Connecticut Yankee Atomic Power Company

Notice of Receipt of UFSAR

Change No.: 04-04

**HADDAM NECK PLANT
FINAL SAFETY ANALYSIS REPORT
November 2004 Update
Insert Instructions**

CONNECTICUT YANKEE ATOMIC POWER COMPANY
GENERAL SITE PLAN
CY HADDAM NECK PLANT

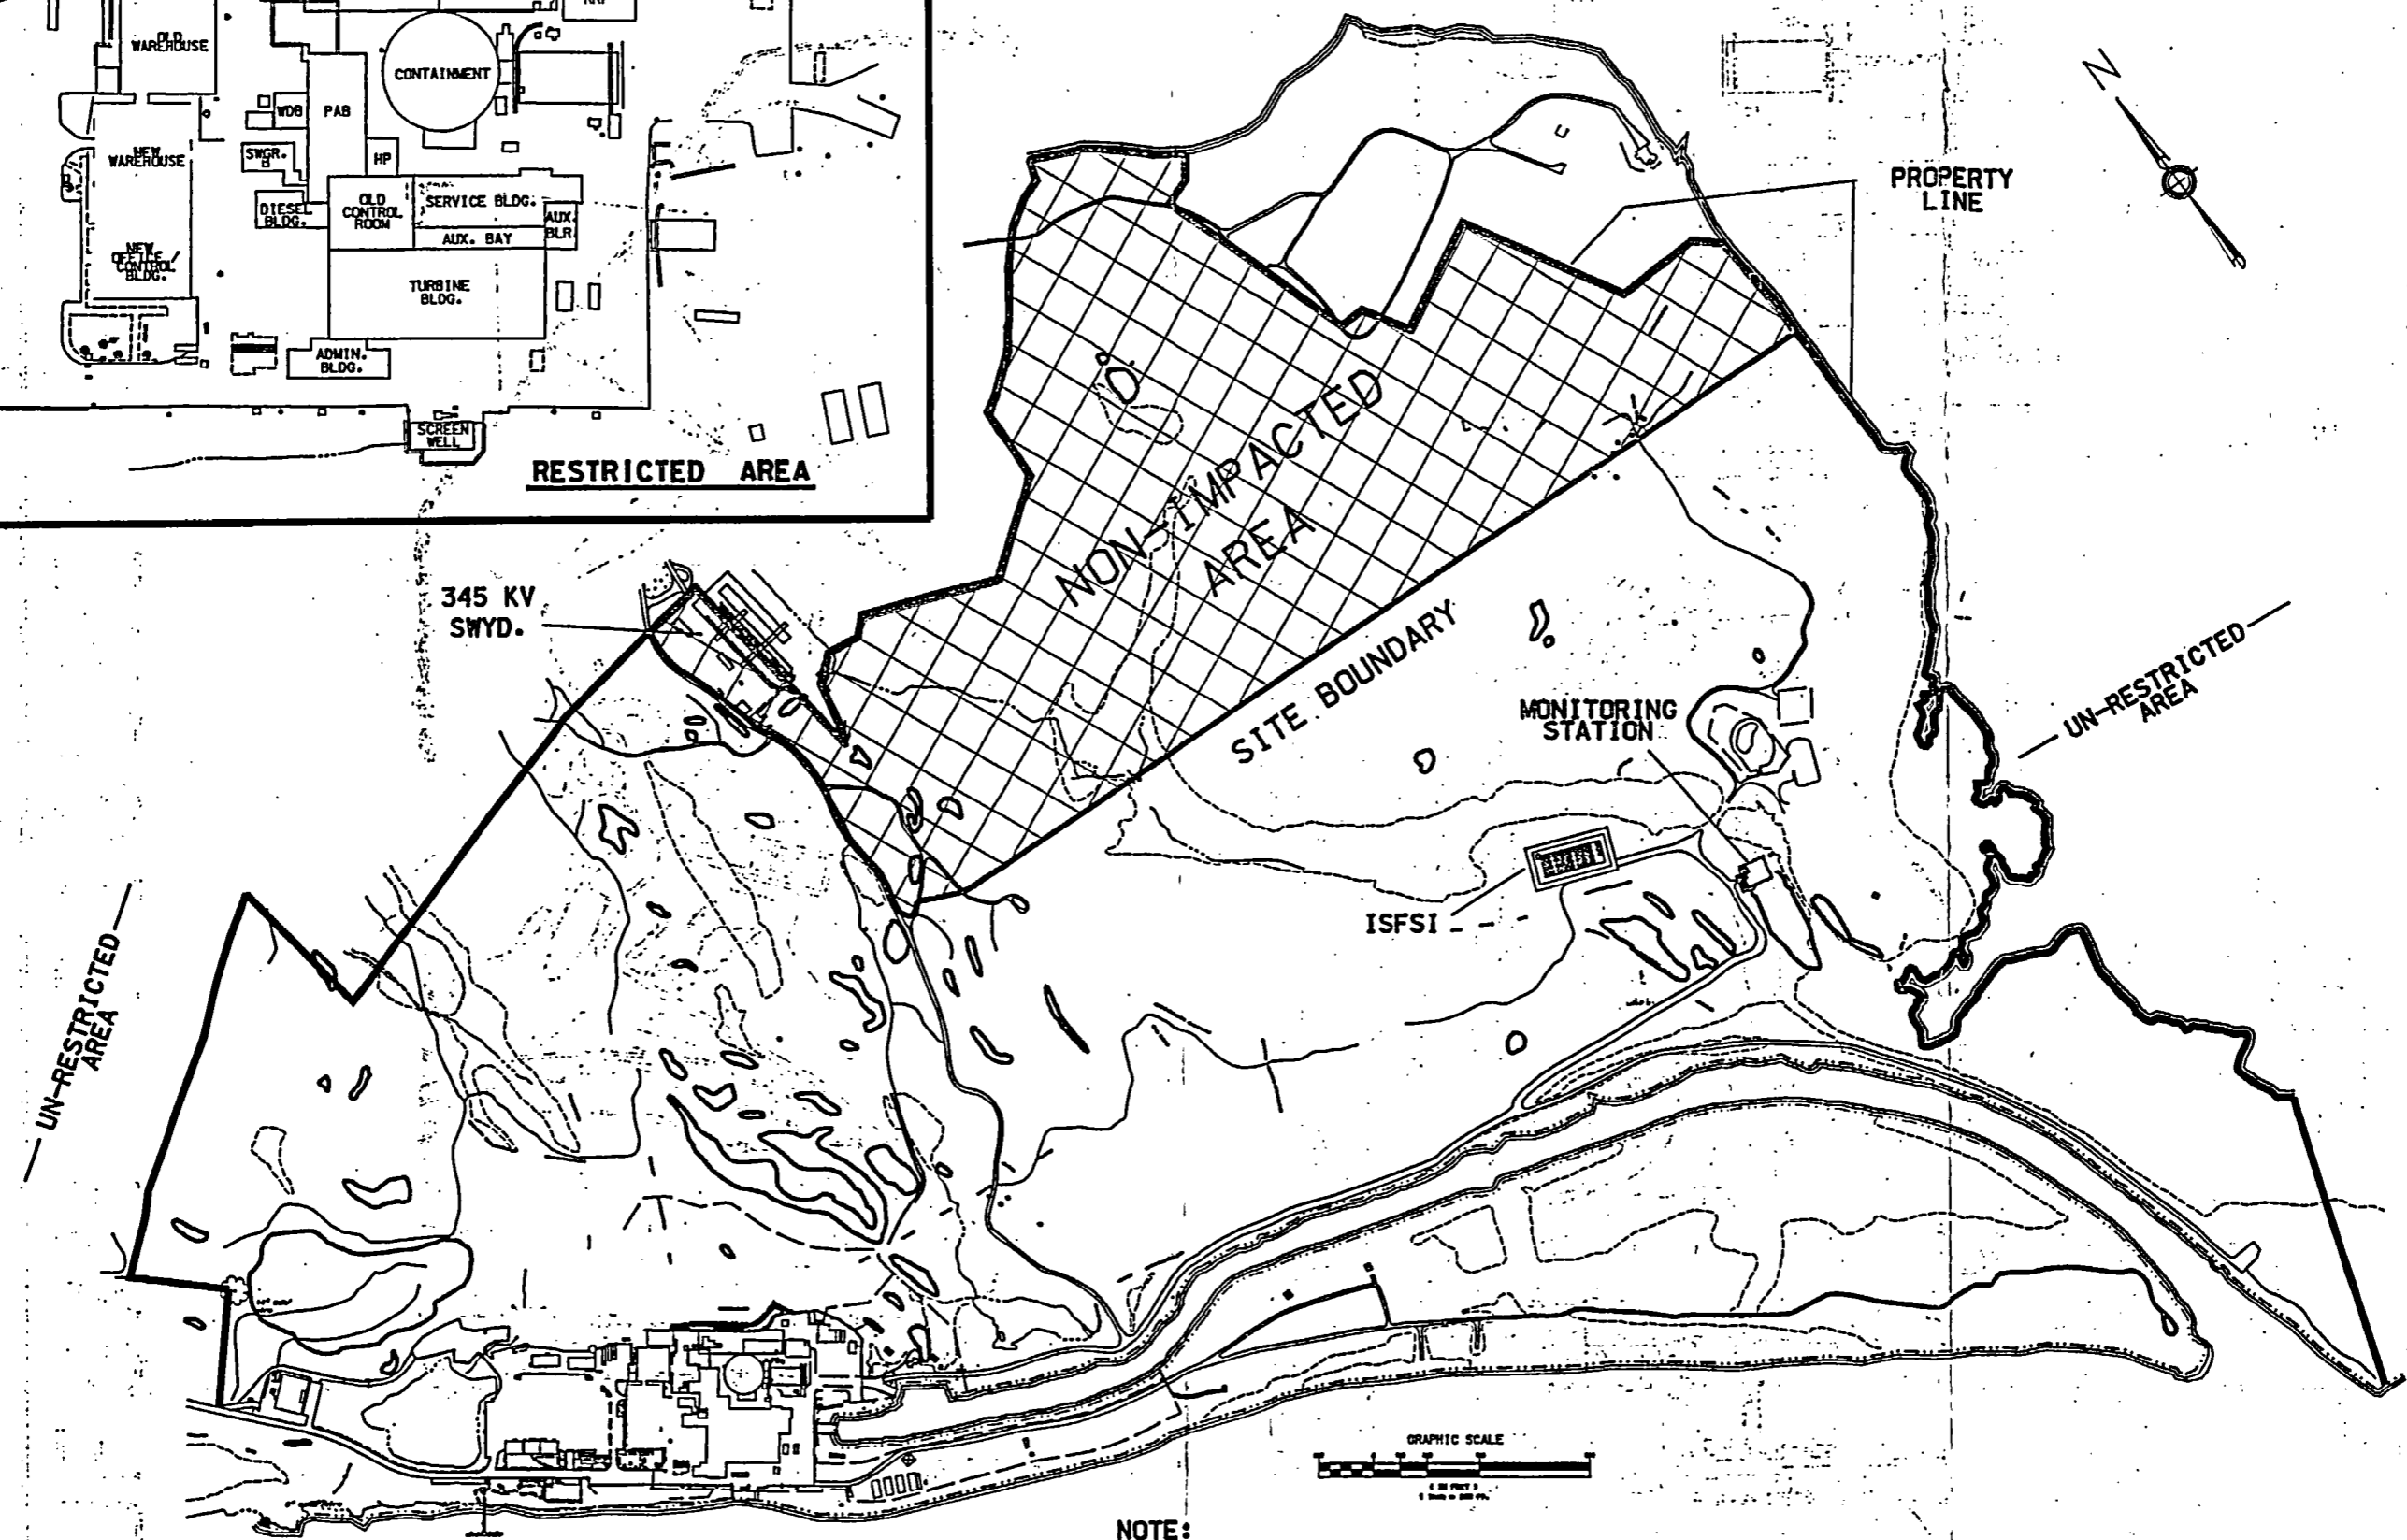
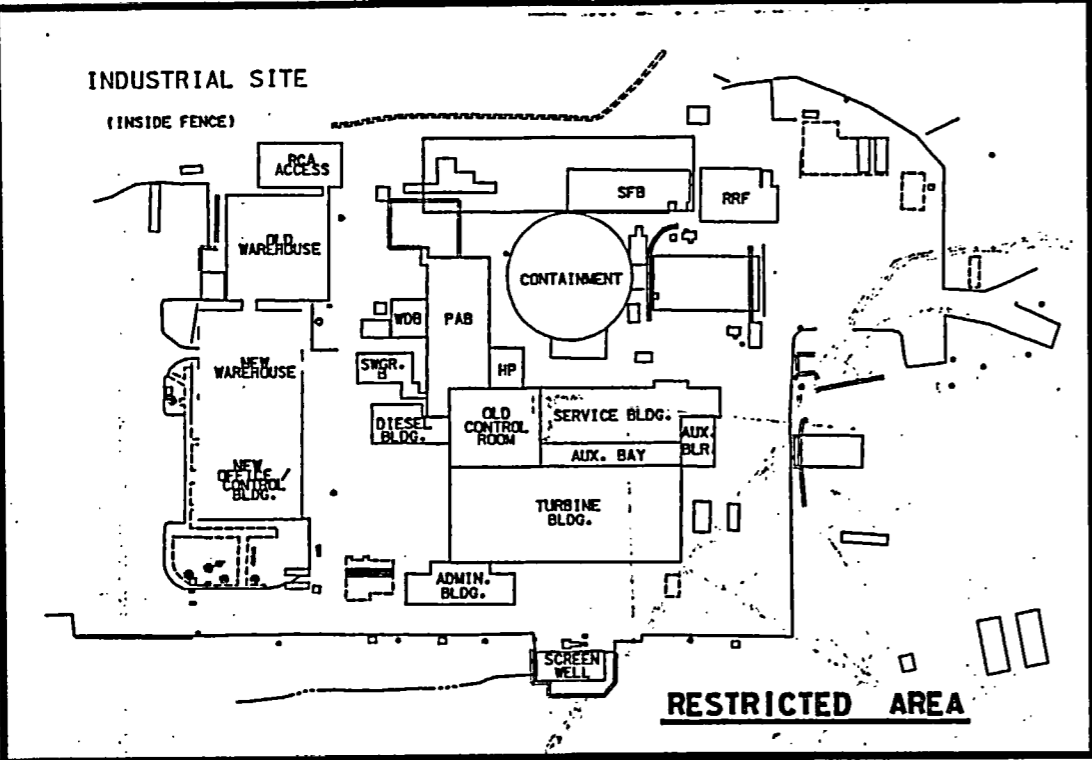
Remove Page Number(s)	Effective Date	Insert Page Number(s)	Effective Date	Justification
List of Effective Pages, Pages EP-1 through EP-6	August 2004	List of Effective Pages, Page EP-1 through EP-6	November 2004	Admin. change
Chapter 2, Page 2-i	July 2002	Chapter 2, Page 2-iv	November 2004	N/A
Chapter 2, Page 2-iv	July 2000	Chapter 2, Page 2-iv	November 2004	LBDCR #37
Chapter 2, Page 2.1-1	July 2002	Chapter 2, Page 2.1-1	November 2004	LBDCR#37
Chapter 2, Page 2.1-2	February 2004	Chapter 2, Page 2.1-2	November 2004	LBDCR#37
Chapter 2, Page 2.1-3	July 2002	Chapter 2, Page 2.1-3	November 2004	N/A
Chapter 2, Page 2.1-4	July 2002	Chapter 2, Page 2.1-4	November 2004	N/A
Chapter 2, Page 2.1-5	July 2000	Chapter 2, Page 2.1-5	November 2004	LBDCR#37
N/A	N/A	Chapter 2, Page 2.1-6	November 2004	N/A
Chapter 2, Figure 2.1-3 Sheet 1	January 1998	Chapter 2, Figure 2.1-3	November 2004	LBDCR #37
Chapter 2, Figure 2.1-5	April 2004	Deleted	November 2004	LBDCR #37

The site consists of approximately 525 acres, bounded by the property lines as shown on Figure 2.1-3. The minimum distance overland from the reactor containment to the exclusion area as defined in 10 CFR 100.3, shall be 1,740 ft and the distance to the nearest residence is over 2,000 ft. The largest nearby city, Middletown, is 8 air miles northwest of the plant.

Figure 2.1-3 depicts the property line and site boundary line. The property line is that line beyond which land is not owned, leased or otherwise controlled. The area within the site boundary is governed by the HNP Part 50 License (Reference 2.1-10 and 2.1-11).

The land outside the bounds of the site boundary is considered an unrestricted area for radiation protection purposes. The land areas between the site boundary and the security protected area is generally considered a controlled area, access to which can be limited by the licensee. Restricted areas are areas which are limited by the licensee for the purposes of protection of individuals from exposure to radiation and radioactive materials. The Haddam Neck Plant restricted area and industrial protected area generally correspond. Additional restricted areas may be designated by the licensee in the controlled area as necessary to protect individuals against exposure to radiation and radioactive materials. The ISFSI is a restricted area. The restricted areas, the controlled area, and the unrestricted area are shown on Figure 2.1-3.

UFSAR FIG. 8.1-1

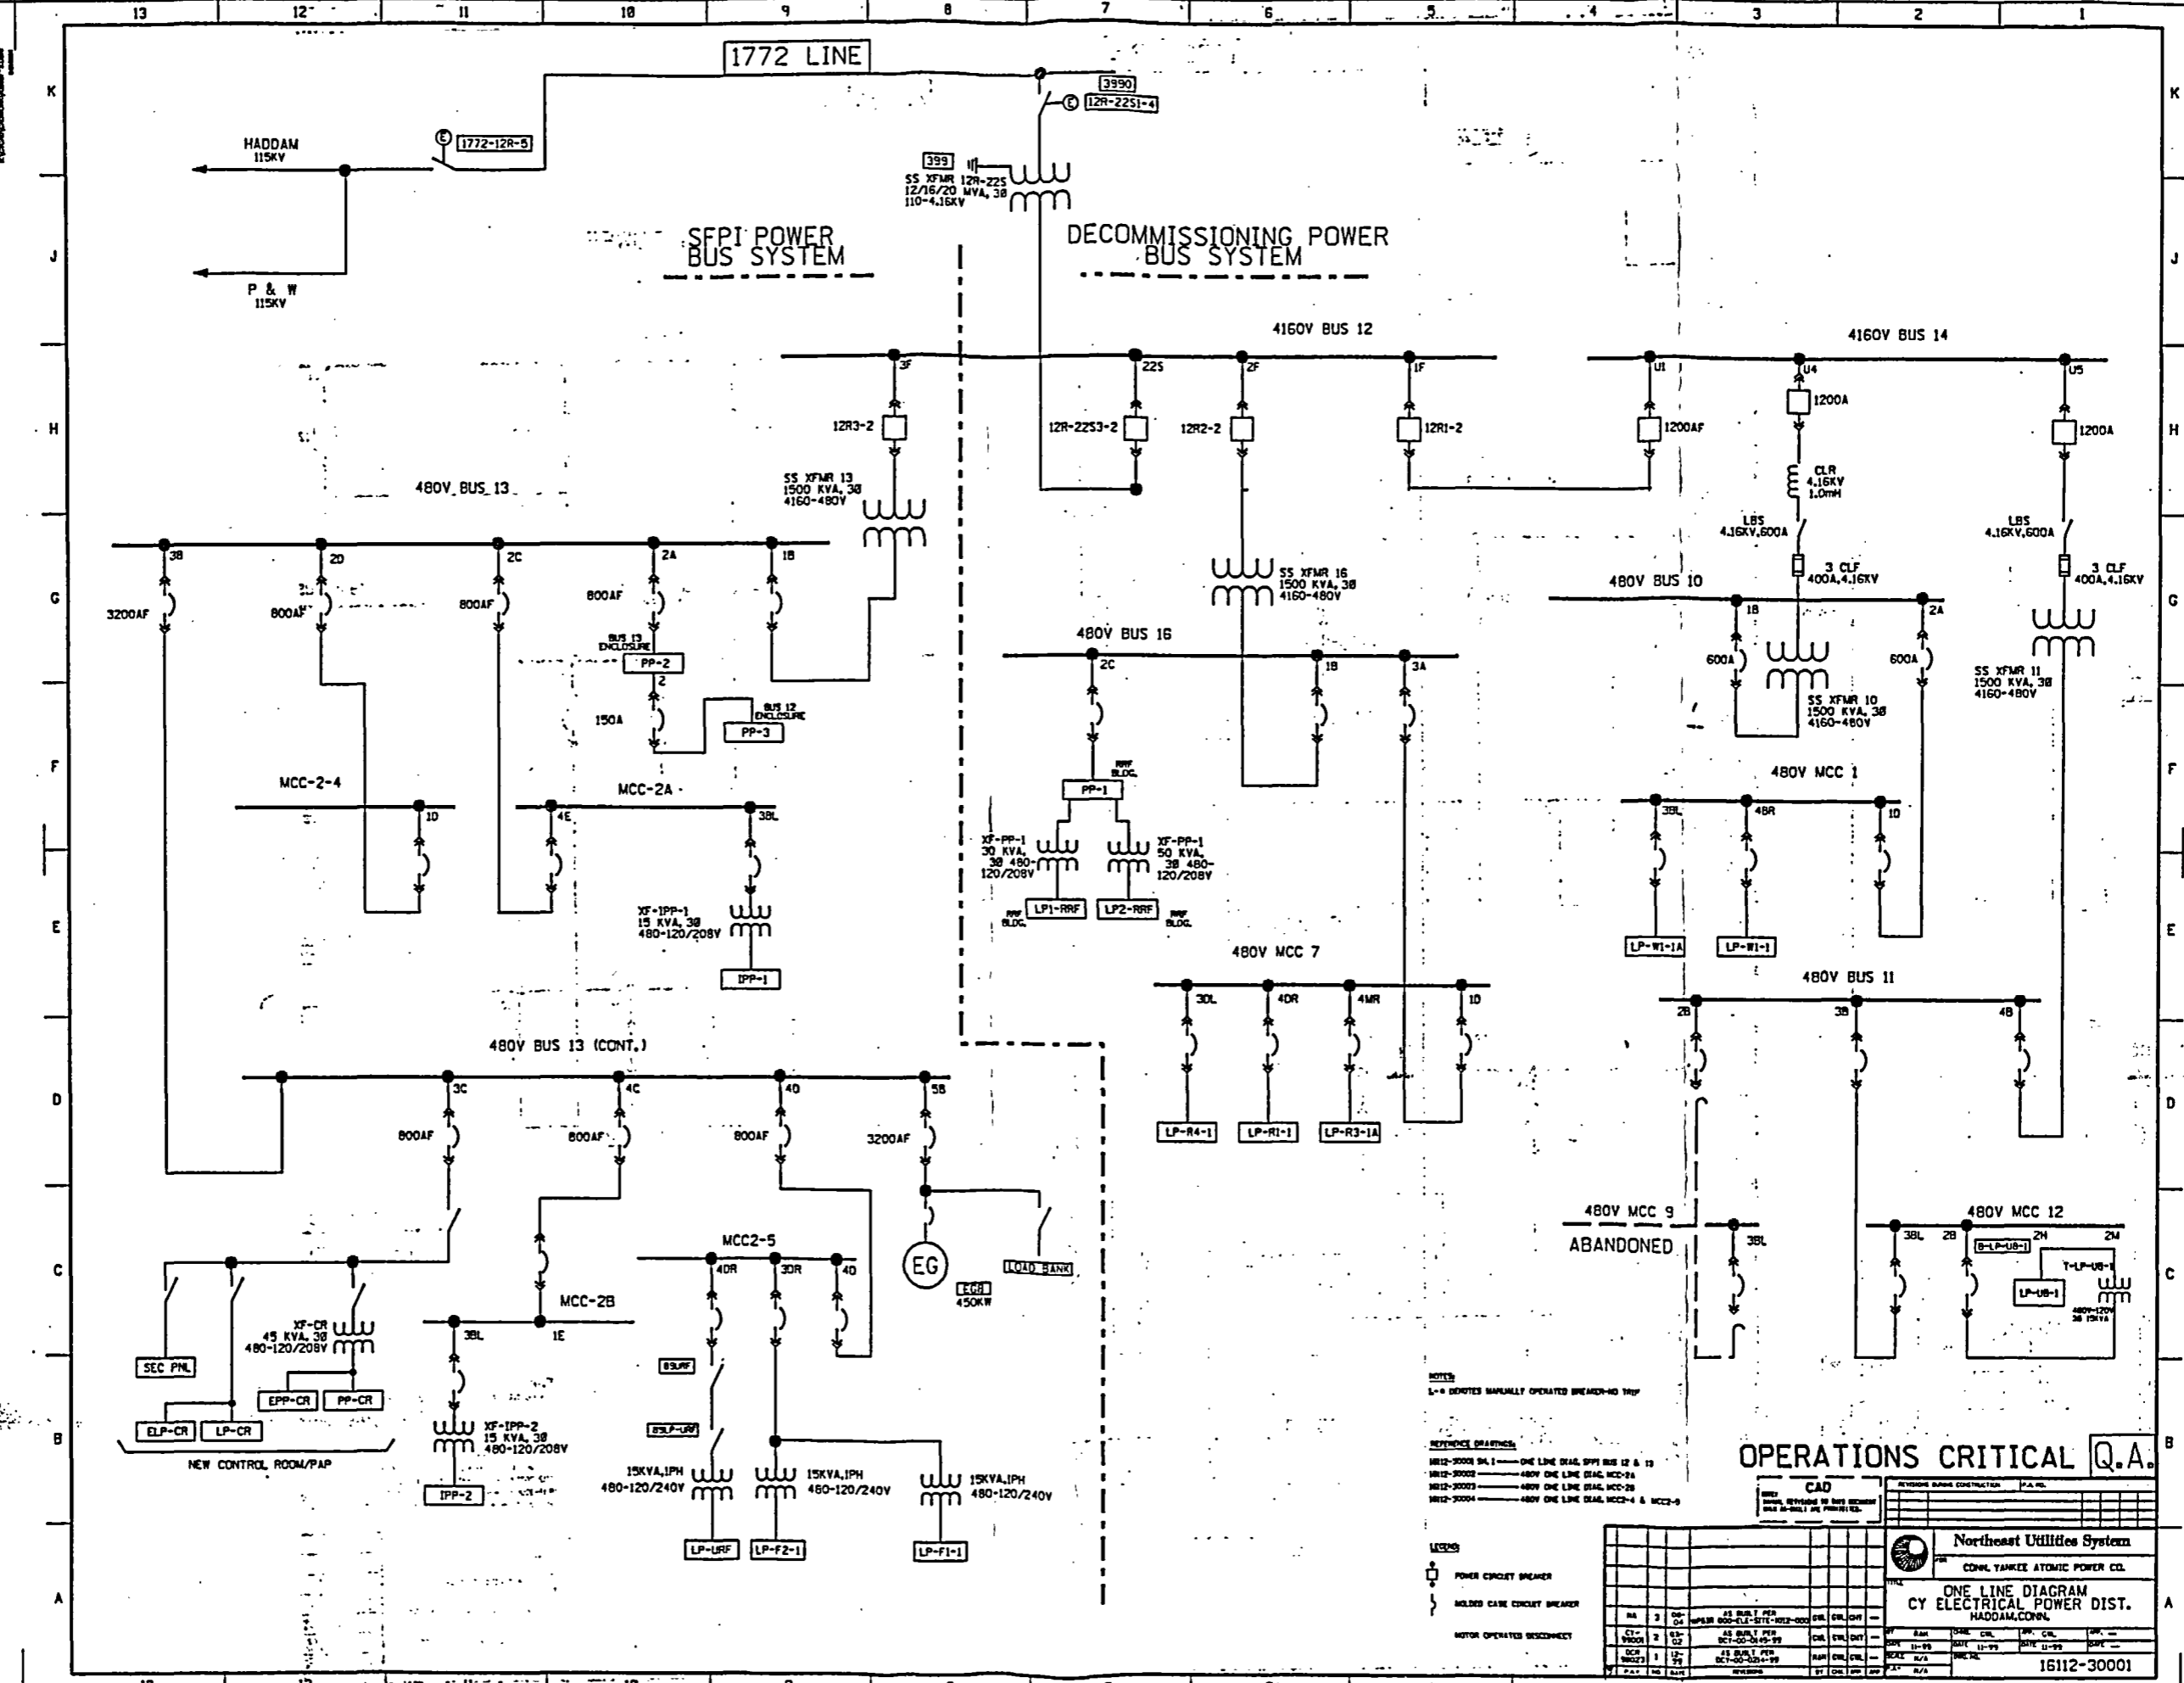
Chapter 3, Page 3.8-1	February 2004	Chapter 3, Page 3.8-1	November 2004	LBDCR #23
Chapter 8, Figure 8.1-1	July 2002	Chapter 8, Figure 8.1-1	November 2004	LBDCR #26
Chapter 8, Figure 8.1-2	July 2002	Chapter 8, Figure 8.1-2	November 2004	LBDCR #26
Chapter 8, Page 8.2-1	July 2002	Chapter 8, Page 8.2-1	November 2004	LBDCR #26
Chapter 11, Page 11.5-3	July 2002	Chapter 11, Page 11.5-3	November 2004	LBDCR #35

The 115 kV off-site power system is designed to provide reliable and adequate source of power for SFI operations. Details of the off-site power system are shown on Figure 8.1-1.
